**Lauderhill City Center
Responses to Statement of Information Needed
(First Round)**

Submitted on behalf of:

LM TIC I LLC, LM TIC II LLC, LM TIC III LLC, LM TIC IV LLC, and LM IDEAL, LLC,
LM TIC I LLC, LM TIC II LLC, LM TIC III LLC, LM TIC IV LLC, and LM IDEAL, LLC

December 19, 2008

Map J - Transportation Network

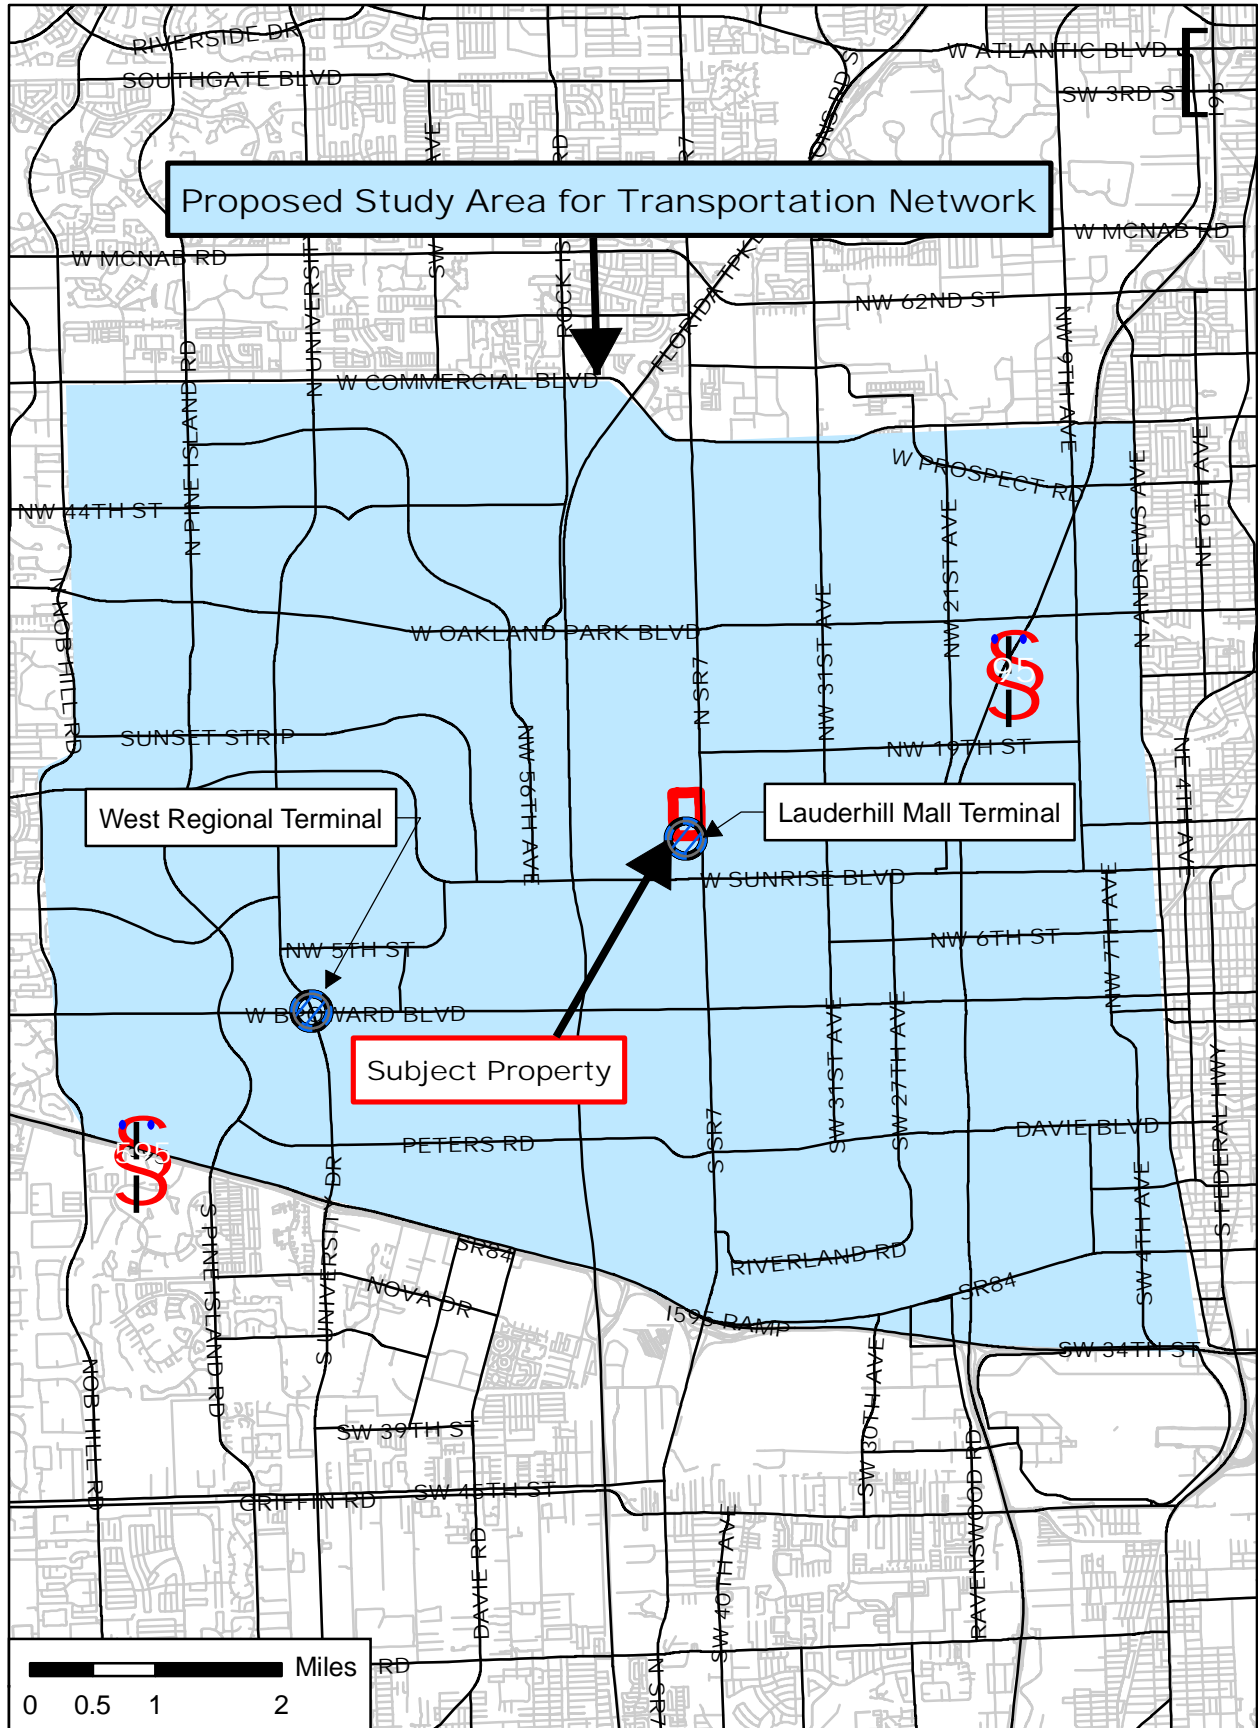
(c) Map J. A map showing the existing highway and transportation network within the study area is required. The provided map shows Commercial Boulevard as the northern boundary of the study area but it does not clearly show the other study area boundaries. It also does not show the public transit Stations within the study area, which include the Lauderhill Mall station and the central station near Broward Boulevard and University Drive,

Response: *The maps have been revised in accordance with the foregoing comments. Please note that Map J has been updated with bus terminals. We feel that the boundaries have been clearly indicated and include: Commercial Boulevard to the north, Andrews Avenue to the east, Interstate 595 to the south, and Nob Hill Road to the west. Regard Map D, the land use map has been revised to show abutting uses. Map D.1 has been created to show on-site uses. All of revised maps are attached as Composite Exhibit A.*

GREEN SPACE AT END OF PHASE 2

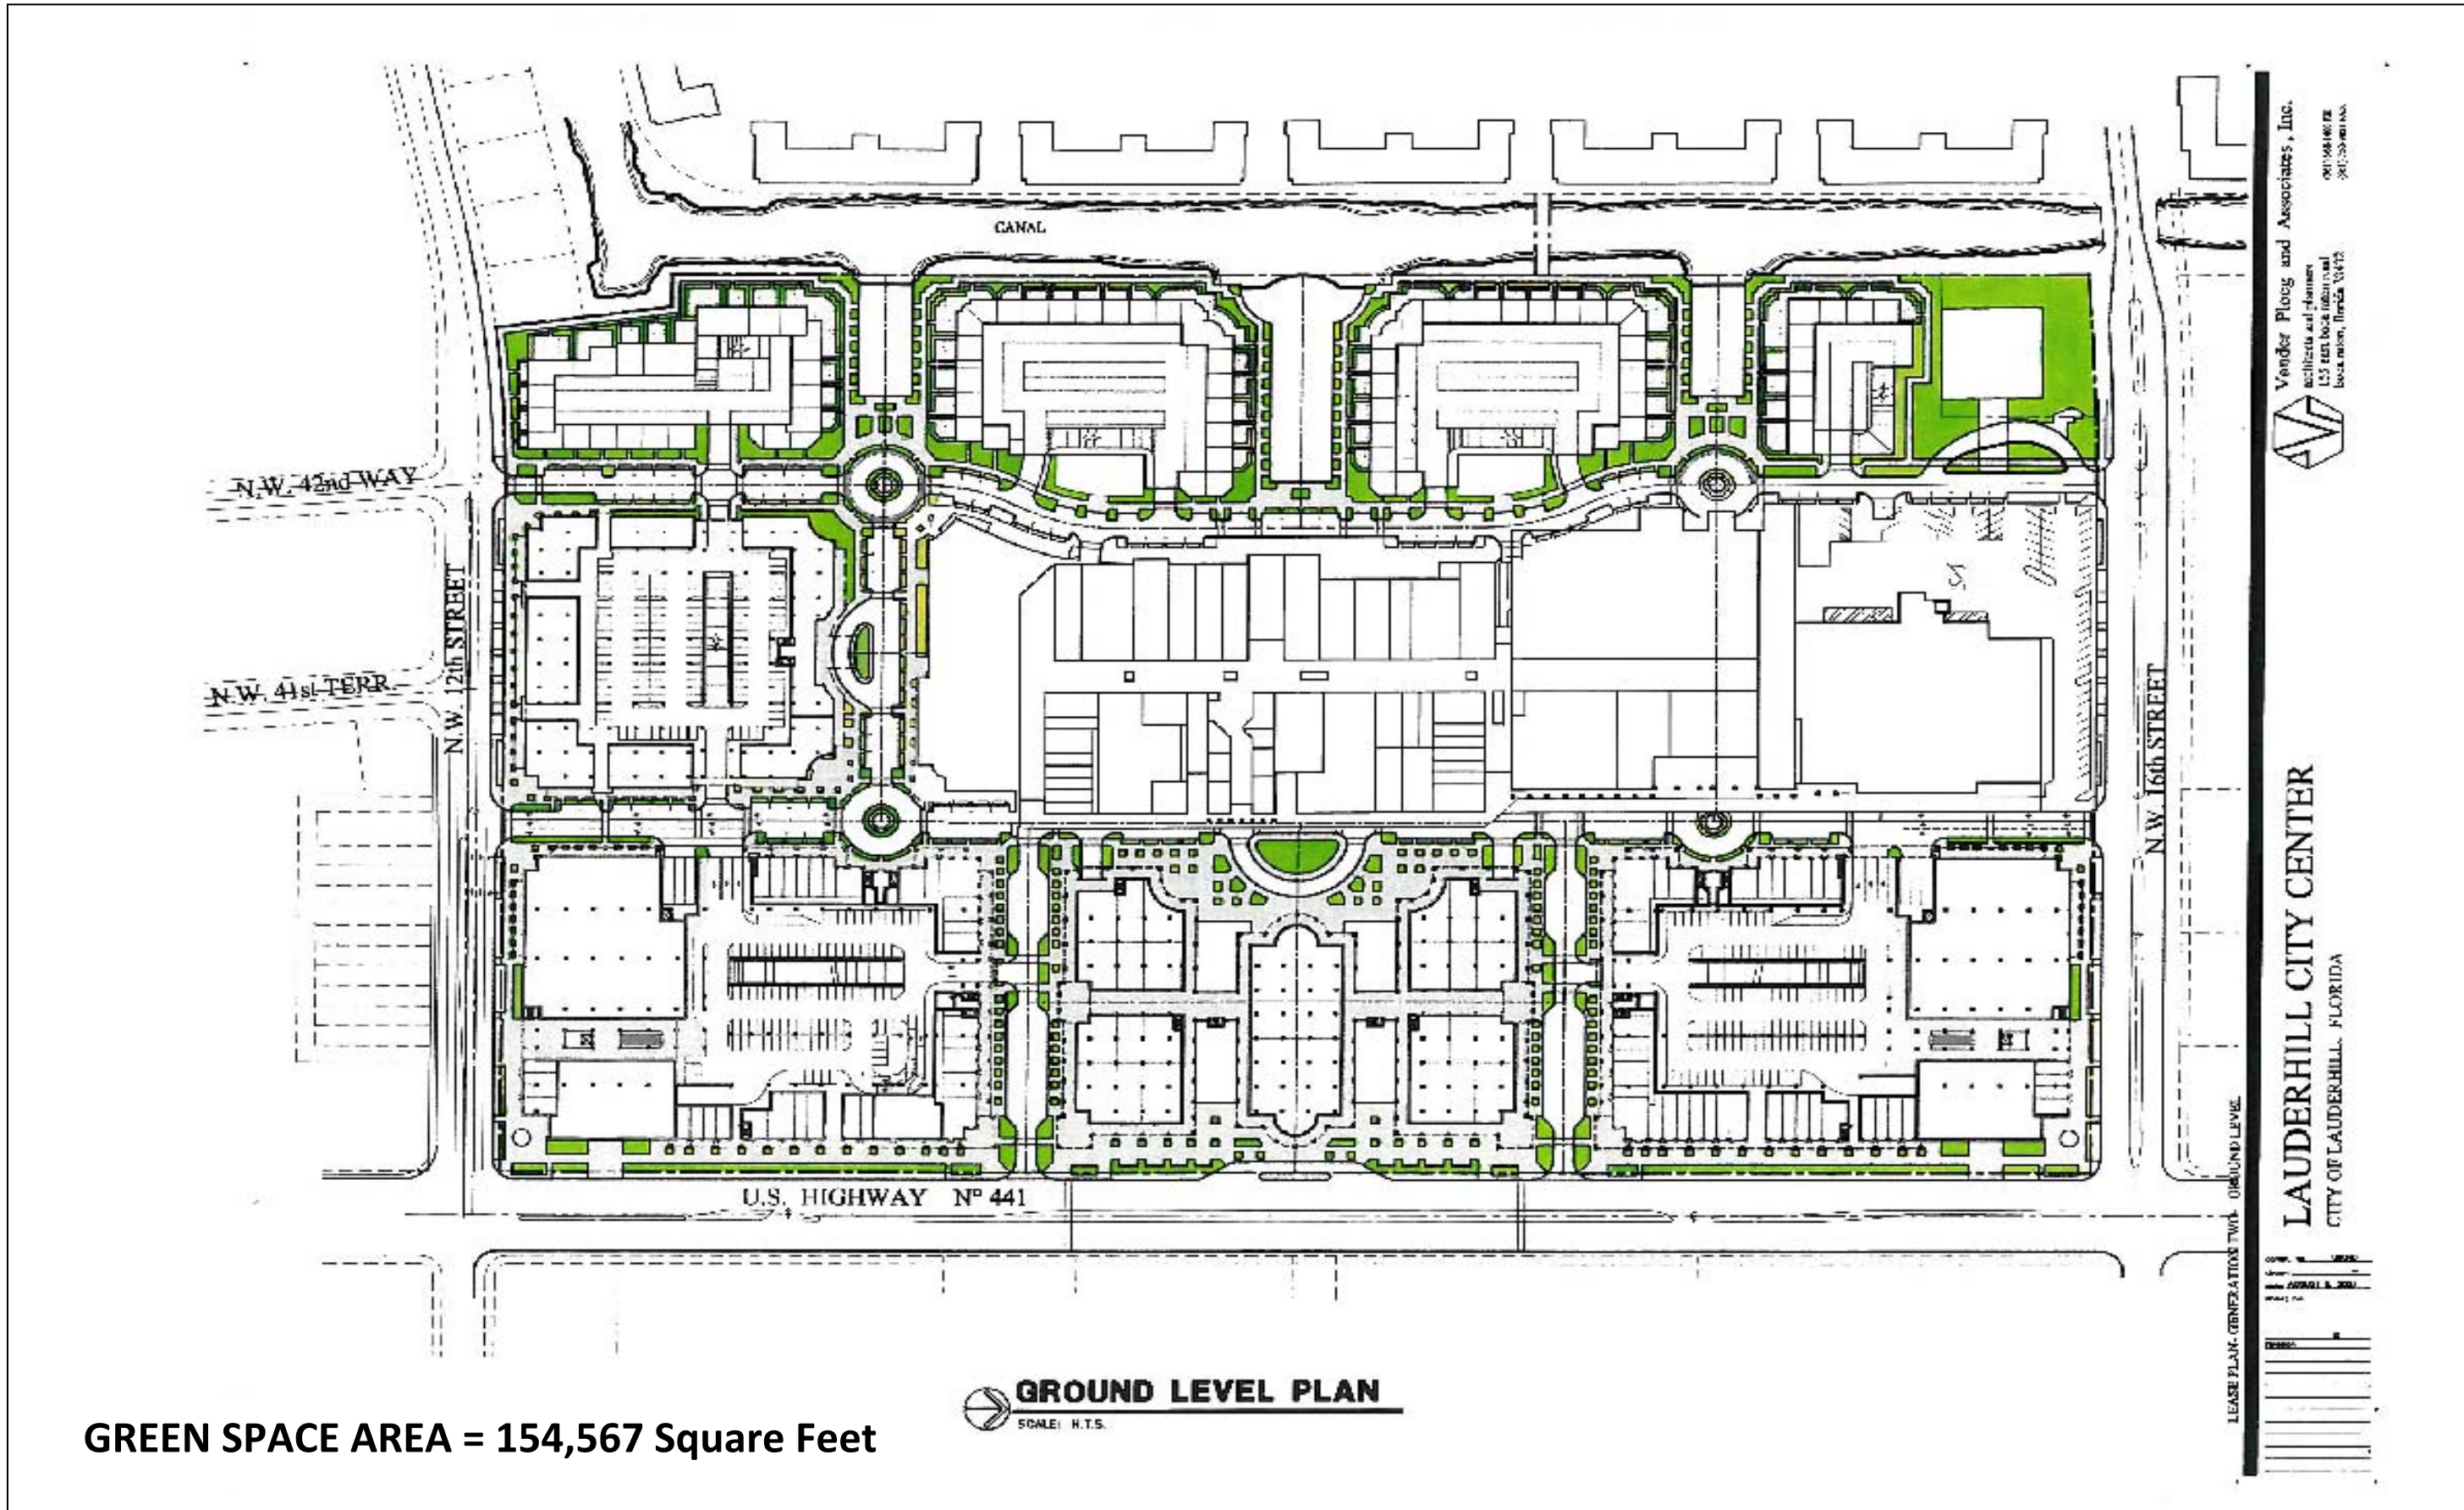
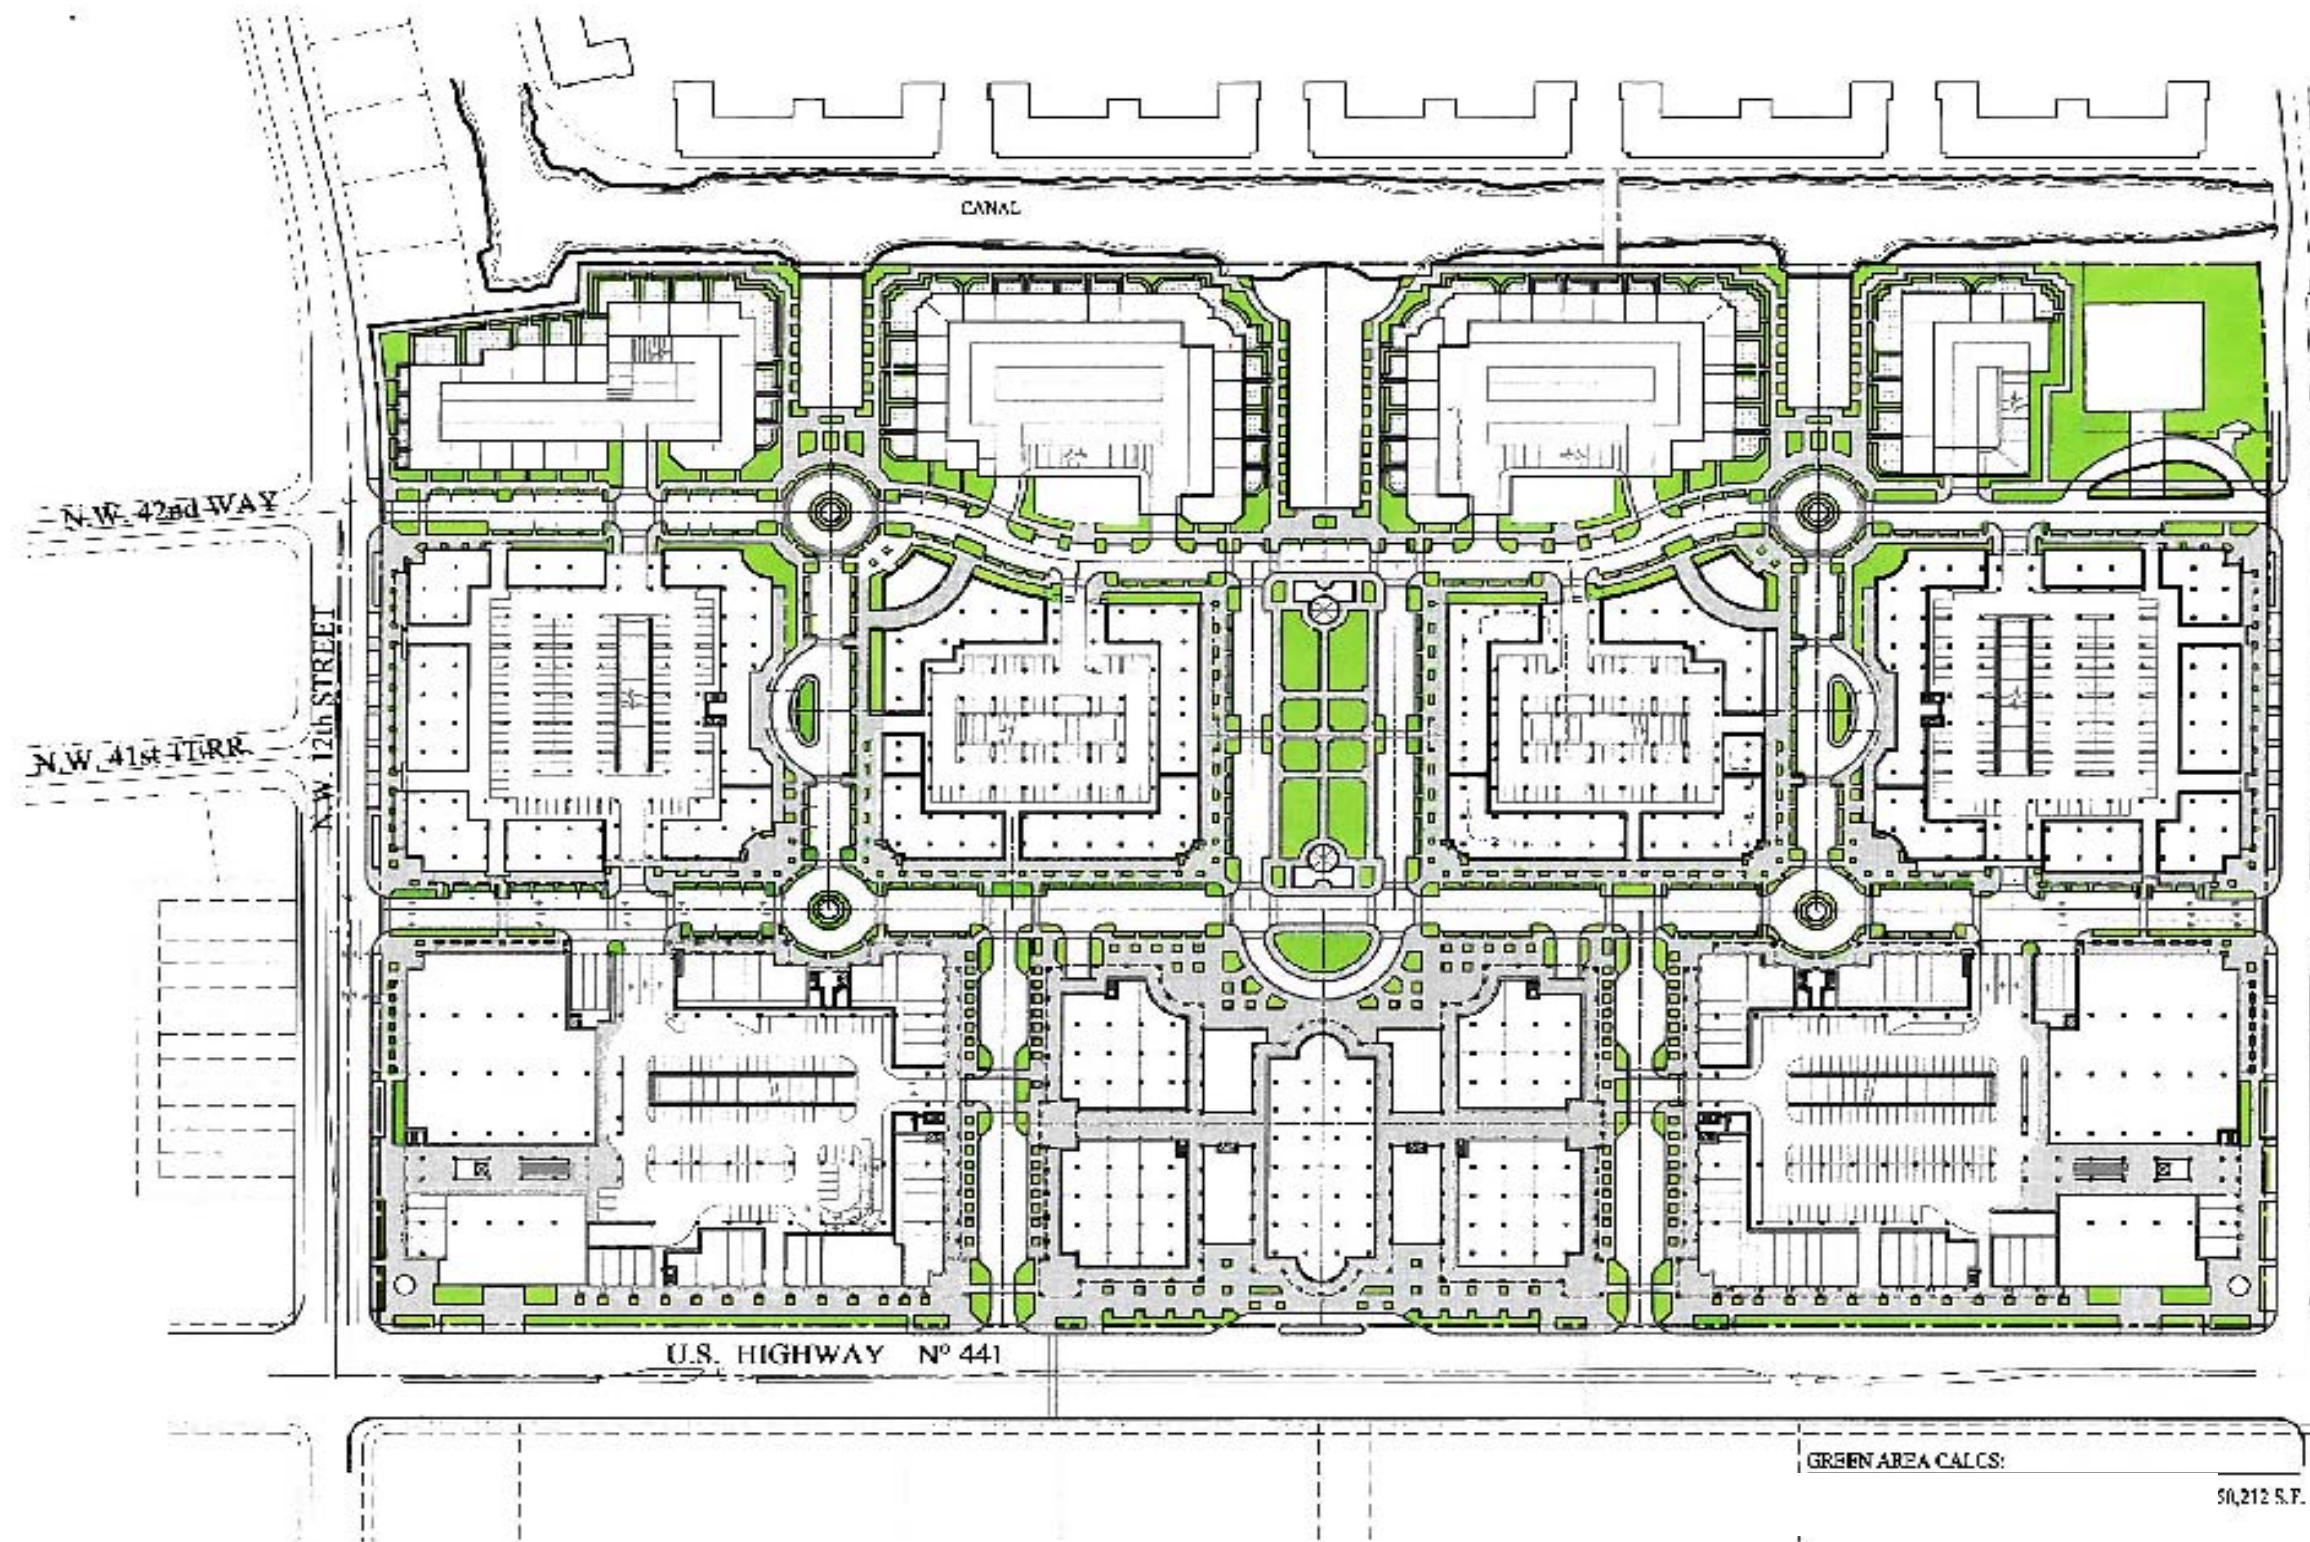
Comment: The Applicants response is insufficient because Section A provides insufficient discussion and/or visual representation of what will be included as open space, particularly as it relates to the residential development. The discussion is limited to what the open space does not include. The Applicant has proposed this project as a Transit Oriented Corridor development, therefore, additional information on open space components is required.

Sidewalks are not defined as open space. The definition of open space, and level of service for open space, is established in the City of Lauderhill's Comprehensive Plan. Applicant is requested to recalculate the total acreage that will be dedicated to open space (not including sidewalks) and to include discussion of urban open space or green space/pocket park uses integrated with the Transit Oriented Corridor and will promote recreational opportunities.

Applicant's Response: *The project has limited traditional open space, such as parks or large fields, because it is a high density, compact, urban development. Excluding sidewalks, the Lauderhill City Center will provide approximately 250,212 square feet of open/green space (as depicted on the figure attached as part of Composite Exhibit D). The project has been planned in such a manner to ensure that it would become a true transit-oriented development (TOD), containing high densities that focus the local population around a transit station. This is in stark contrast to the ubiquitous sprawl model seen throughout South Florida where large suburban tracts have been developed with low density*
